**VOLUNTARY REMEDIATION PROGRAM
SECOND SEMI-ANNUAL PROGRESS REPORT
FORMER MACON 2 MGP FACILITY
MACON, BIBB COUNTY, GEORGIA
GEC JOB NO. 130659.241**

**SUBJECT: Second VIRP Semi-annual Progress Report
Former Macon 2 MGP Facility
HSI #10692
Macon, Bibb County, Georgia
GEC Job No. 130659.241**

Re: Voluntary Remediation Program First Semiannual Progress Report, March 10, 2016 Macon
Former Manufactured Gas Plant 2, HSI Site No. 10692
Intersection of Willow Street and Spring Street Lane, Macon-Bibb County
Parcels R07 I-03 I 6 (OC98-5J), R073-0033 (OC99-4A), and R073-0398 (OC99-4AB)
Portions of Right-of-Way of Willow Street and Spring Street Lane GEC Job No. 130659.241

FIGURE 3: SOIL MANAGEMENT MAP
0 TO 15-FOOT INTERVAL
FORMER MACON 2 MPG SITE
MACON, GEORGIA
GEC PROJECT NO. 130659.241

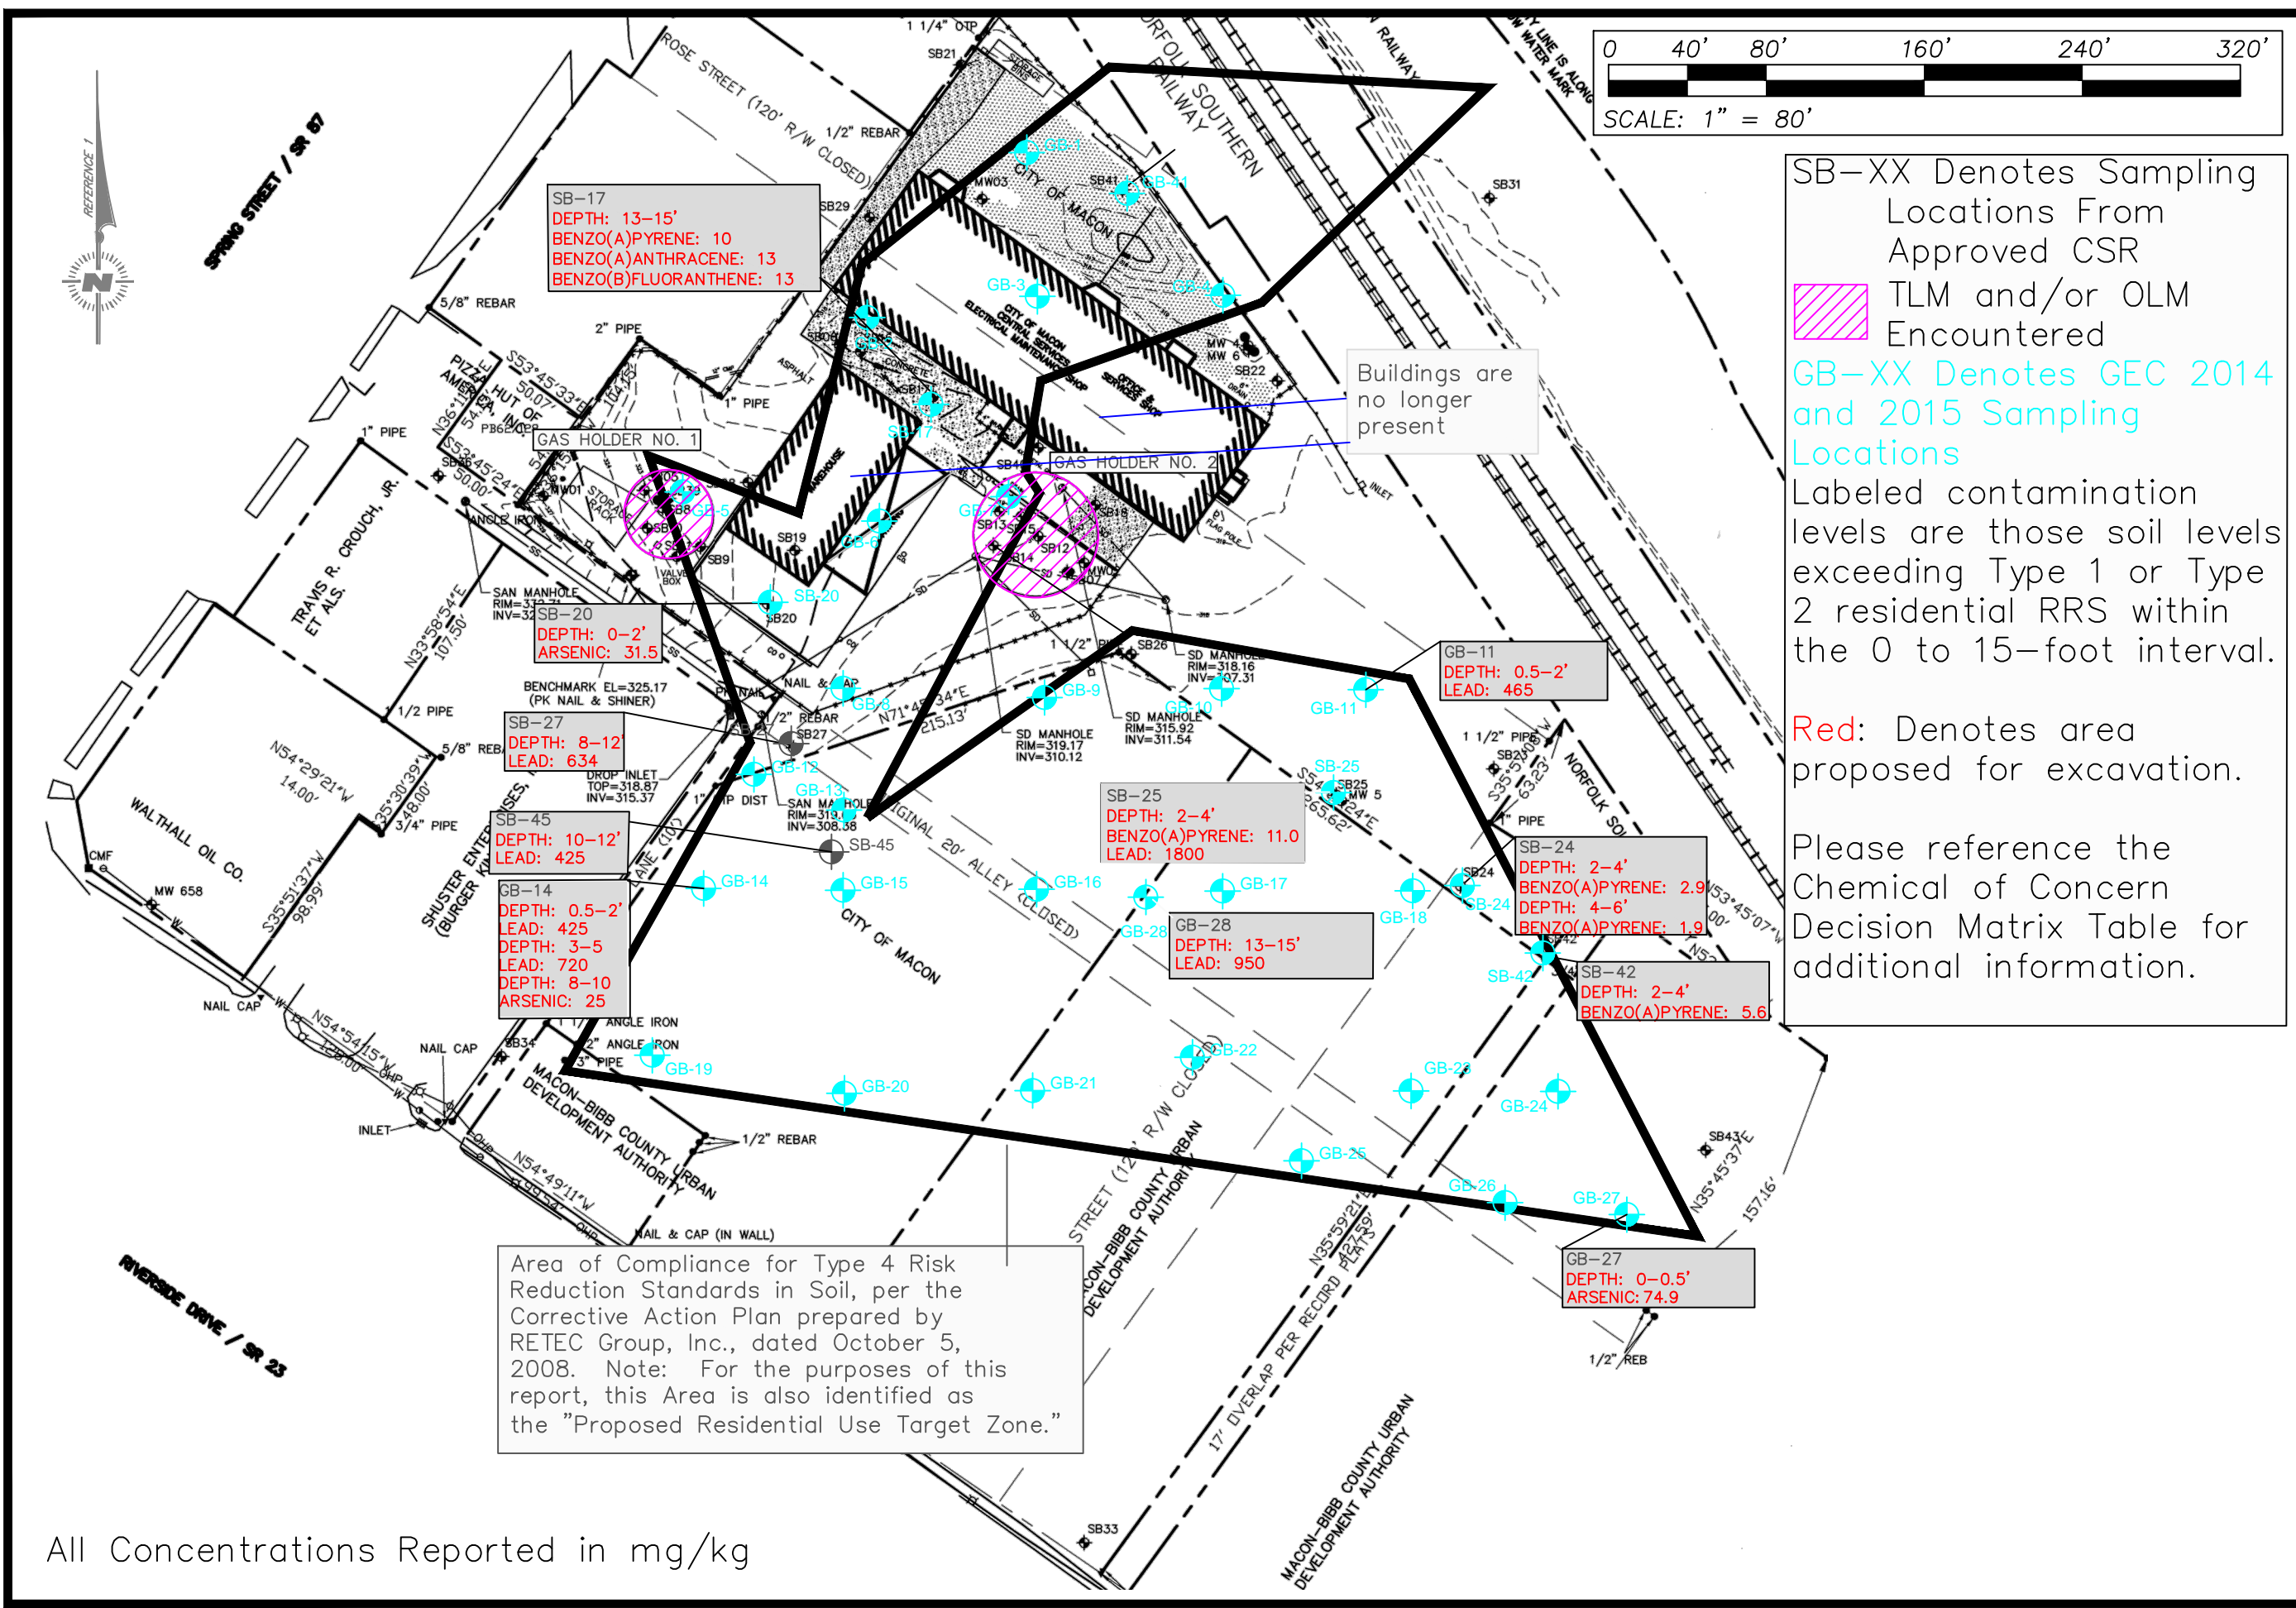
3. According to the Report, the soil impacts at the property have been delineated horizontally and vertically. Please provide a figure in the next semiannual progress report that illustrates delineation to the approved Type 1 RRS, and please note that a final figure that demonstrates overall soil compliance should be submitted in the final Compliance Status Report (CSR).

A figure illustrating compliance with Type 1 or 2 RRS, as previously approved in Compliance Status Investigation Report, prepared by Williams Environmental Services, Inc., will be provided in the next Report and in the CSR.
